RE: Crescent Park Slope Stabilization

DATE:	5/23/2025	JOB NO:	22006.00
ATTENTION:			
RE: Emergency Slope Repairs Rose Larisa Memorial Park 701 Bullocks Point Avenue East Providence, RI

Re: Sand Berm Construction & Beach Nourishment
Crescent Park and Sabin Point
East Providence, RI 02915
CRMC File #: 2023-10-015
FREG Project No. 22006.00

**CRESCENT PARK SHORELINE PROTECTION
 CRESCENT PARK
 EAST PROVIDENCE, RHODE ISLAND**

1 PROPOSED SAND PLACEMENT PLAN - OVERALL
 SCALE: 1" = 50'

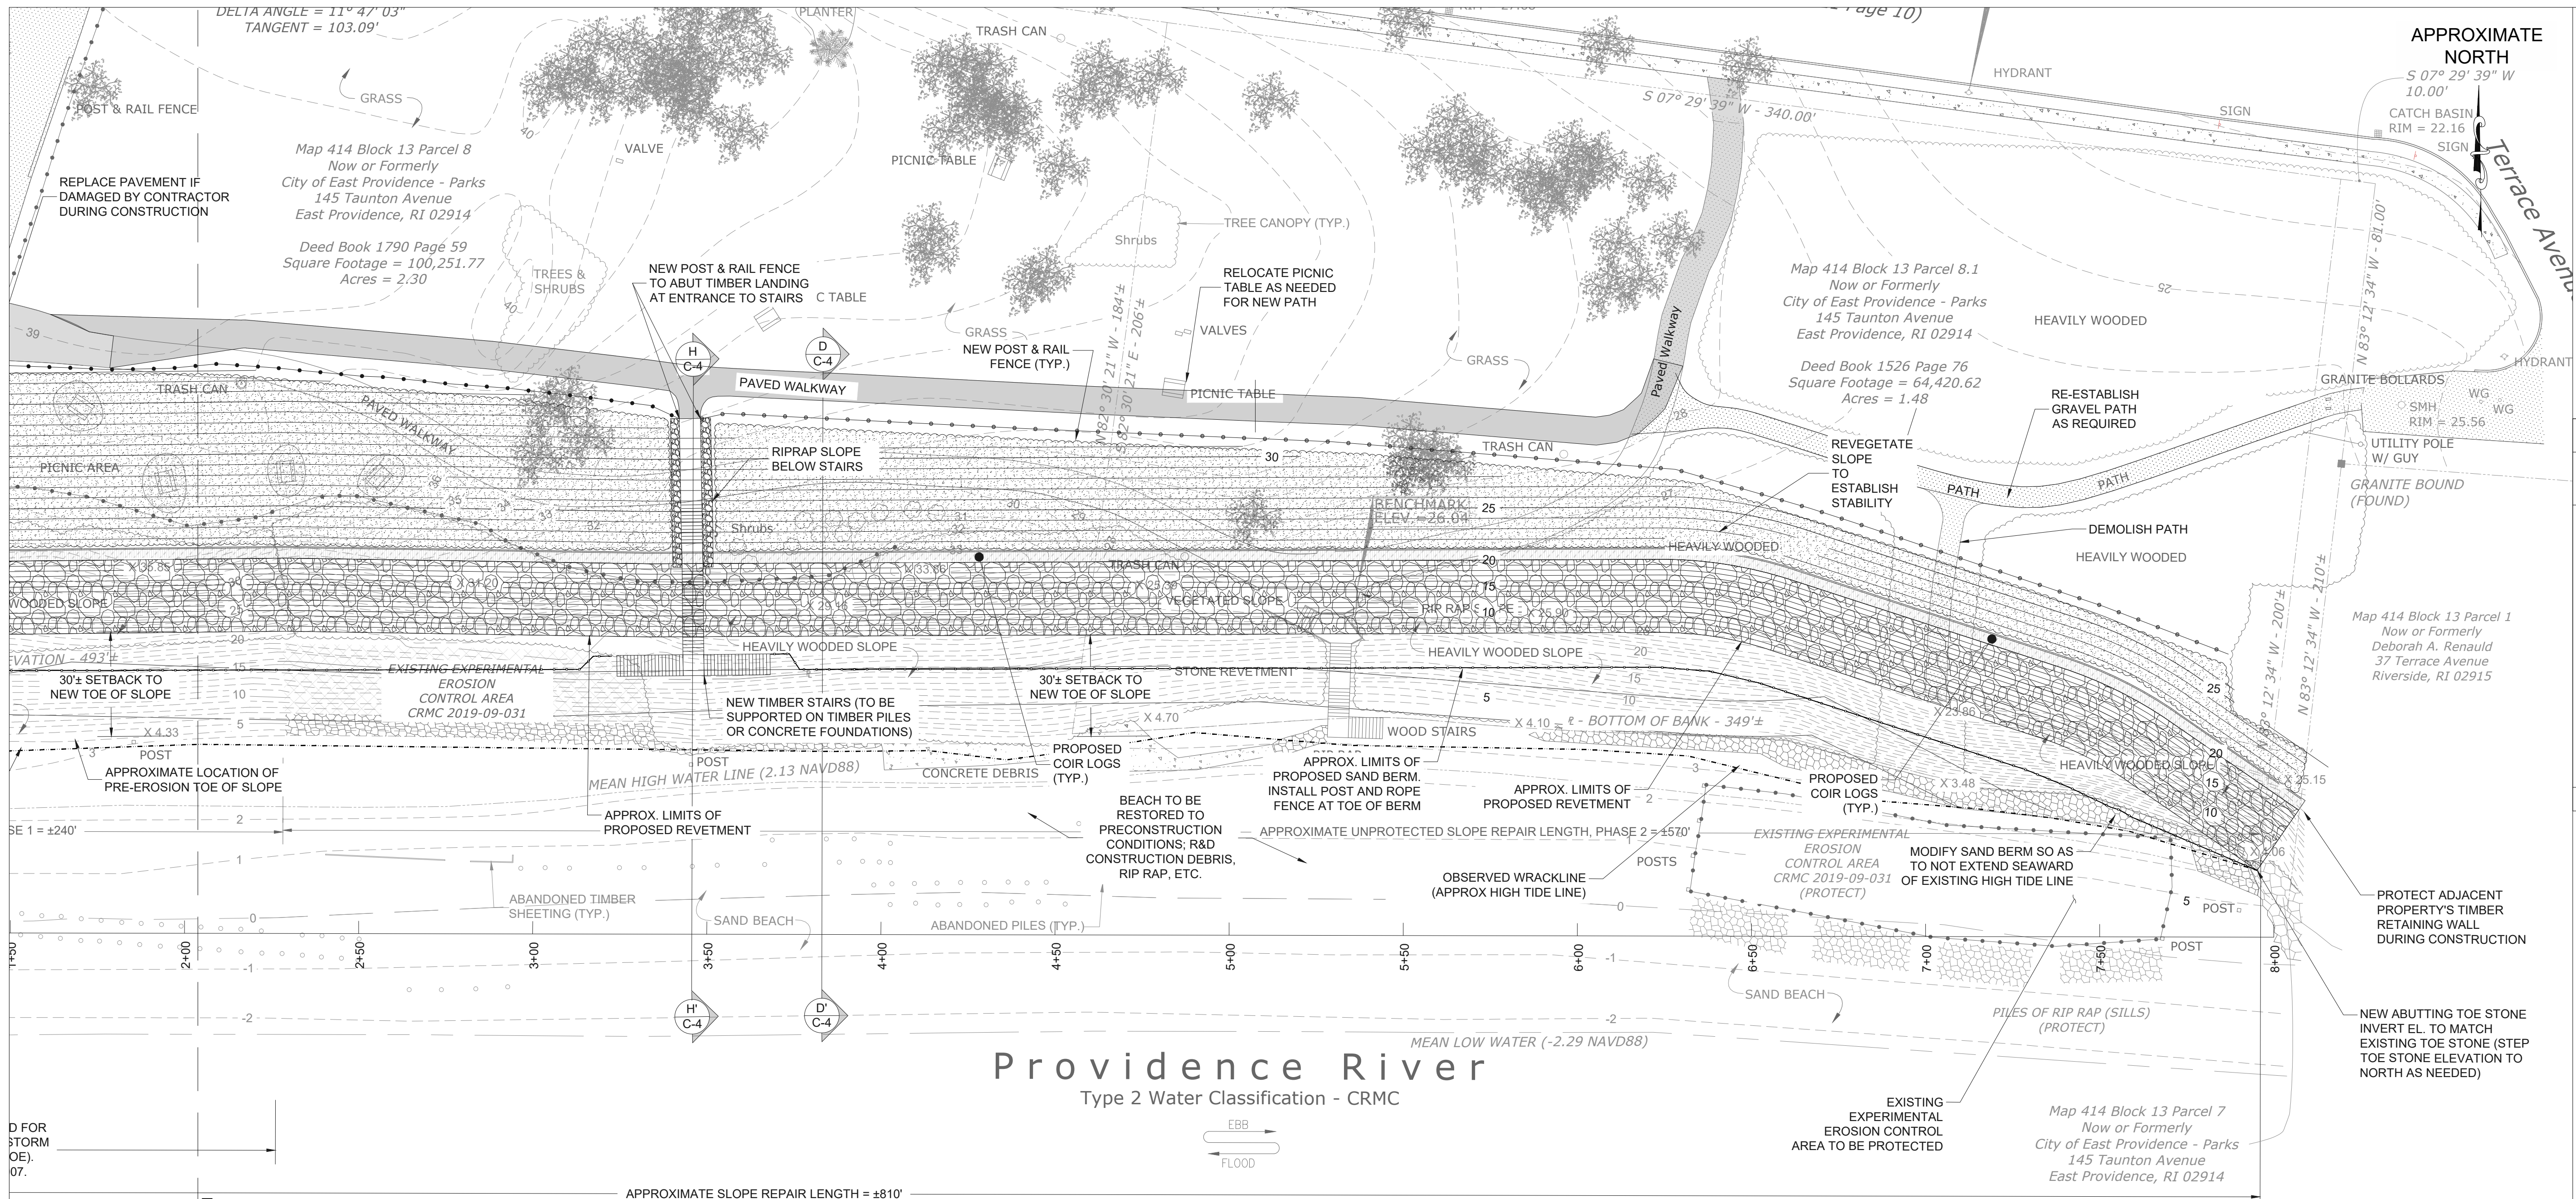
1. Construct a 10 ft wide sand berm along the seaward side of the proposed revetment toe at a maximum slope of 3H:1V;
2. Plant American beachgrass on the sand berm spaced at 1 foot on center;
3. Install post and rope fencing at the toe of the sand berm to protect vegetation;
4. Place sand in the revetment stone matrix, as feasible;
5. Place sand in the revetment stone matrix along Crescent Park's northern shoreline (CRMC # 2022-02-036), as feasible;
6. Place sand at end of Beach Road (above high tide line) after completion of the new stormwater system construction; and,
7. Regrade beach profile seaward of the sand berm up to the high tide line at a maximum slope of 10H:1V where feasible.

1 PROPOSED SAND BERM PLAN
C-5 C-5 SCALE: 1" = 20'

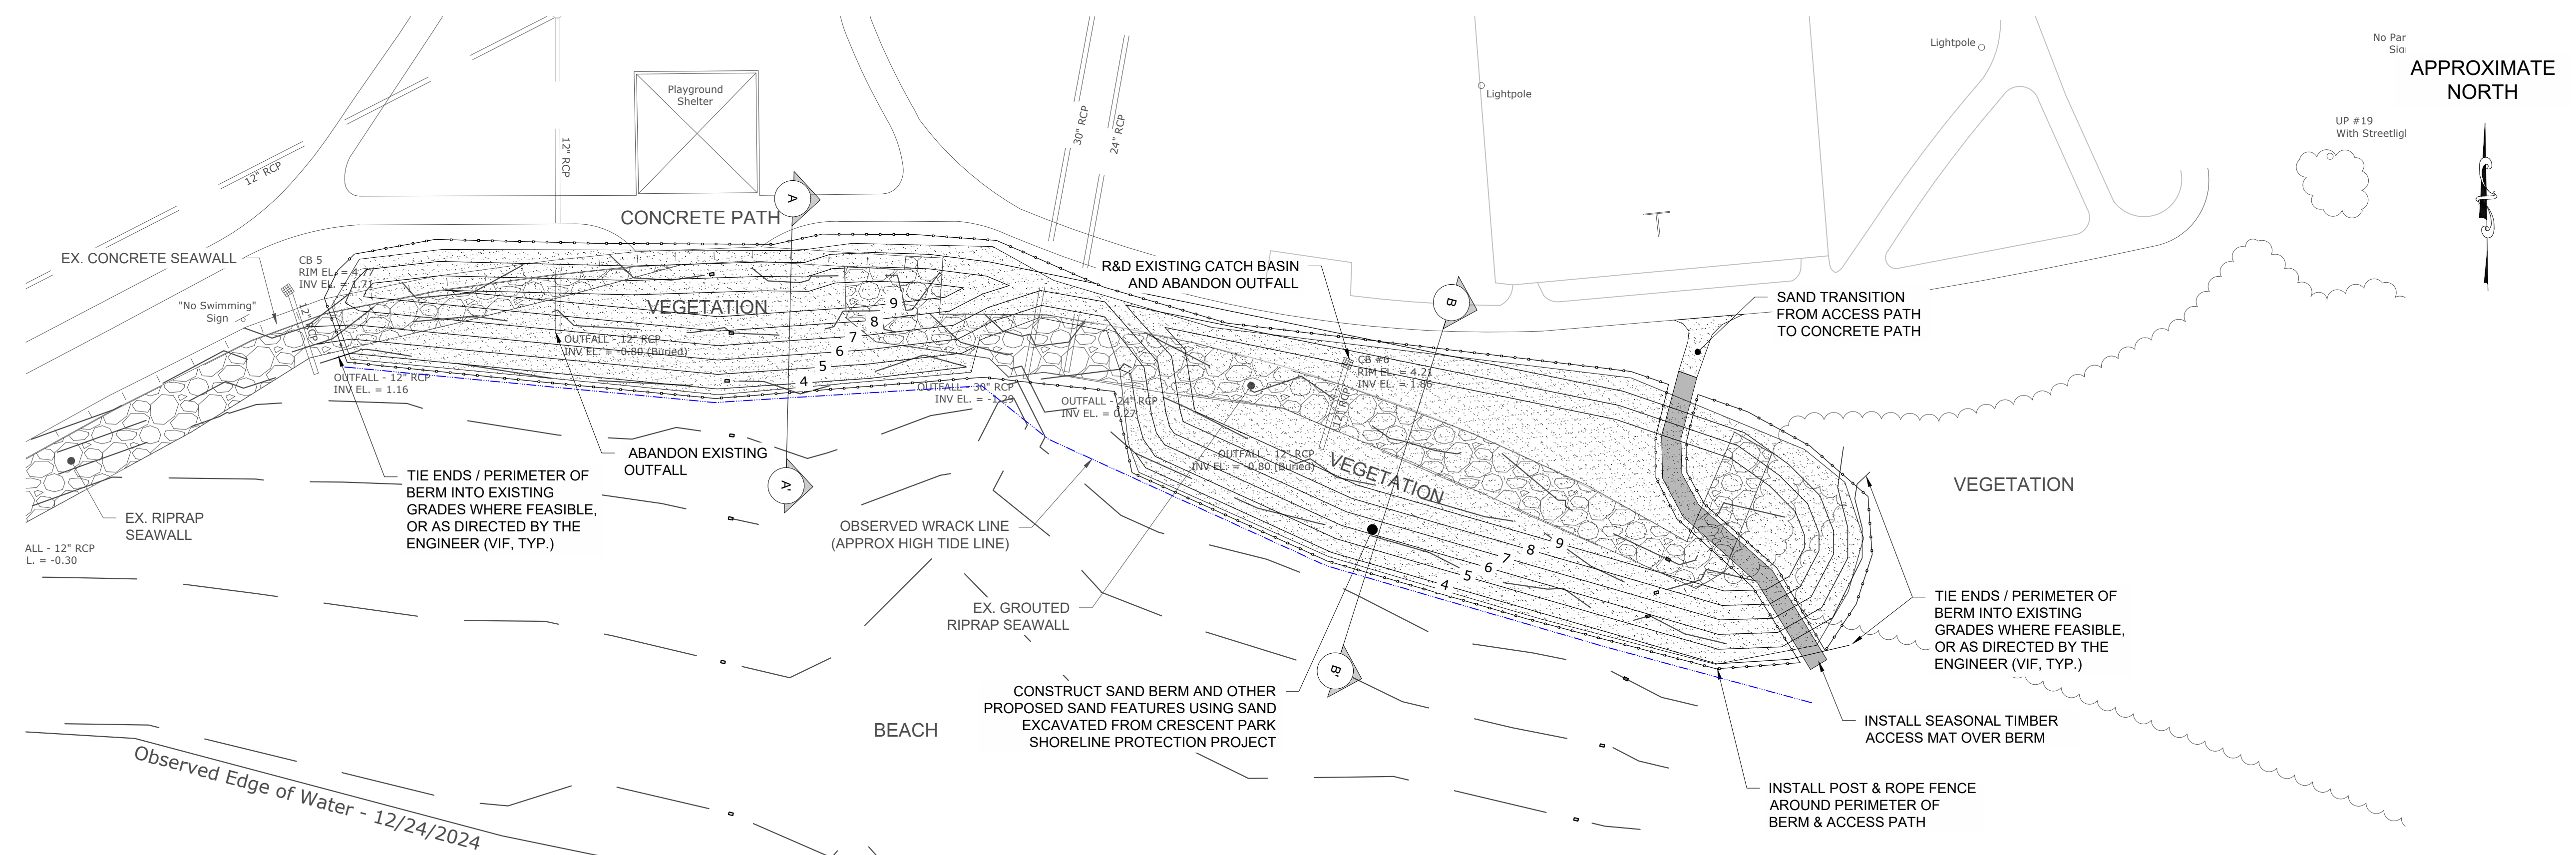
1. Construct sand berm with a maximum slope of 3H:1V;
2. Plant American beachgrass on the sand berm spaced at 1 foot on center;
3. Remove and demolish/abandon existing buried drainage utilities as shown;
4. Install post and rope fencing around the perimeter of the sand berm to protect vegetation; and,
5. Install timber access mat over sand berm for pedestrian access.
